Planning Commission Minutes
December 14, 2023

16. (PUD-1979) Application by Portland One 50, LLC, to rezone 3261 NW 150th Street from I-2 Moderate Industrial District to PUD-1979 Planned Unit Development District. Ward 8.

STAFF REPORT
The City of Oklahoma City
Planning Commission
December 14, 2023

DRAWING NO. 1 OF 1		CONCEPTUAL PLAN	
DATE:	10/21/2023	DRAWN BY:	
DWG NO:		SHEET SHEET	33
PROJECT NO:		CHECKED BY:	
APPROVED BY:

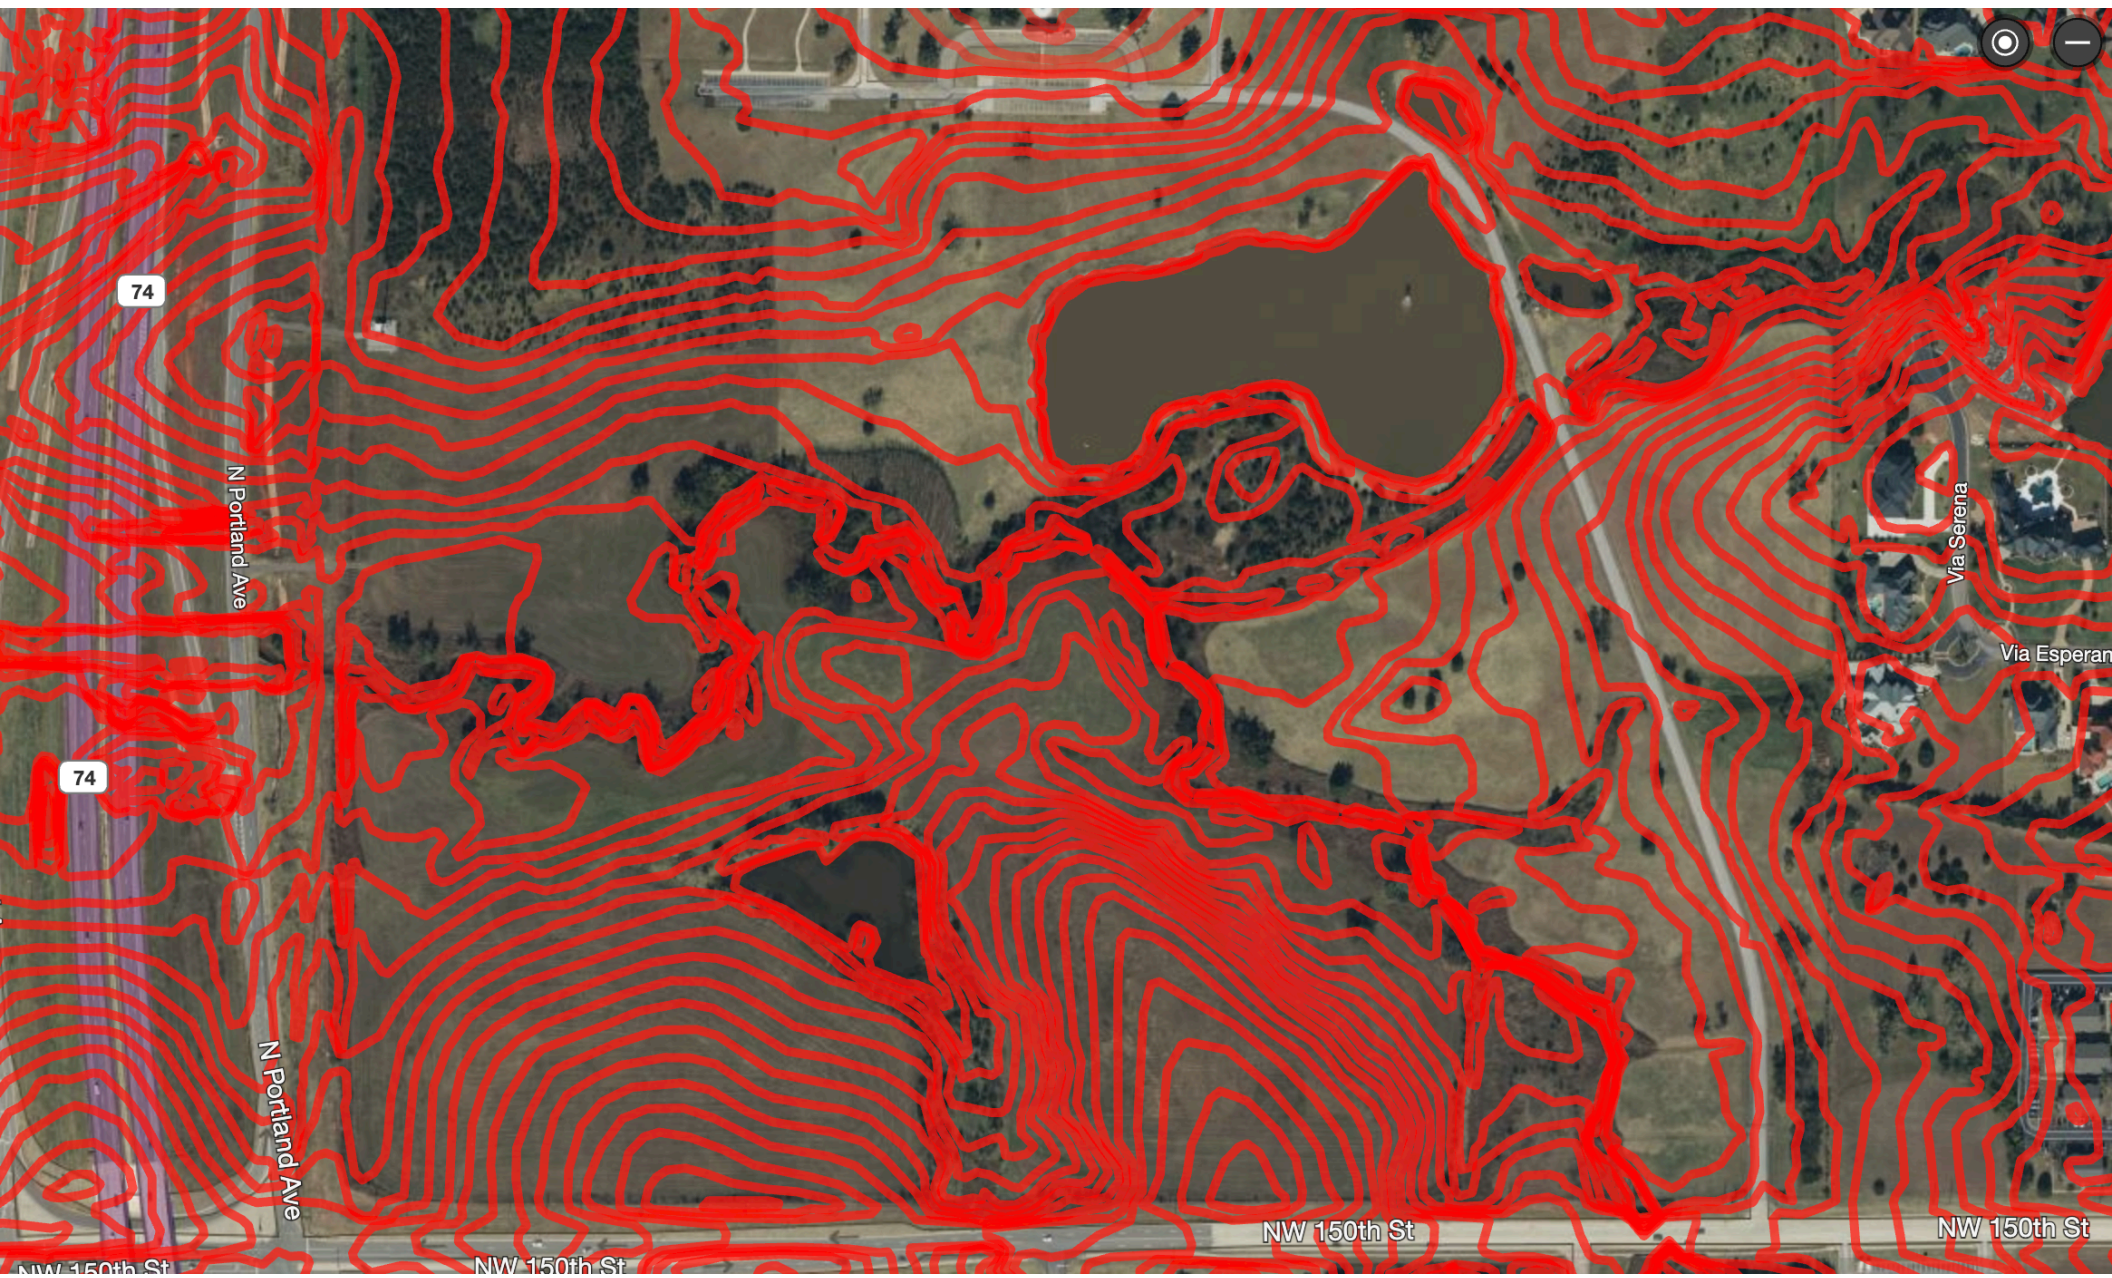
- 1. Airports**
- 2. Central Oklahoma Transportation and Parking Authority (COTPA)**
- 3. Fire:** No objection with secondary access drive running north as shown.
- 4. Information Technology/Geographic Support**
- 5. Parks and Recreation**
- 6. Police**

National, state, and local permitting require basic best management practices for stormwater management. Public water and sewer are available. The PUD is requested to add R-4 residential uses to the commercial and industrial uses already allowed on the site. The PUD establishes a maximum density of 25 du/acre. Conceptual plans indicate apartment buildings oriented toward the creek.

Access will be from NW 150th Street. Additional access may be required per Fire.
